Subject: Arby's Specific Evolution Elite Auto Drain Control Kit
Date: 08/27/21
Region: Global
Models Affected: Evolution Elite Electric and Gas, EEE 14x and EEG 24x

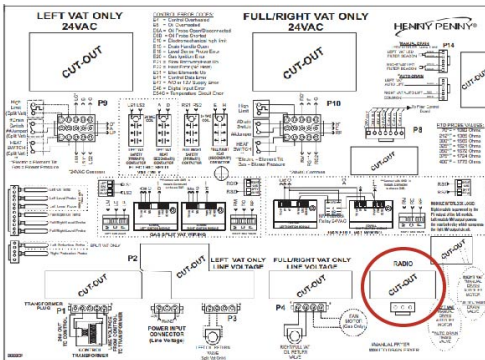
- **140748** – This is a new control kit specific for **Arby's** Evolution Elite fryers with **automatic drains**. *This control includes the RS485 radio connection to connect the Arby's SiteSage radio and comes pre-loaded with Arby's software.*
- **140402** – This is an existing control kit for all other customers using Evolution Elite fryers with **automatic drains**. *This control does not include the RS485 radio connection and requires customer specific software to be flashed onsite. Radio connection location on control marked below with a red circle.*

NOTE: Since it is only used on Arby's fryers and there is a global electronic parts shortage, the RS485 radio connection was removed from the 140402 general market control. The RS485 radio circuit / connection was left in place on the new 140748 Arby's specific control for connection of their SiteSage radio. If you have older 140402 controls in stock with the RS485 radio connector, these can be used to service Arby's Evolution Elite fryers with automatic drains.
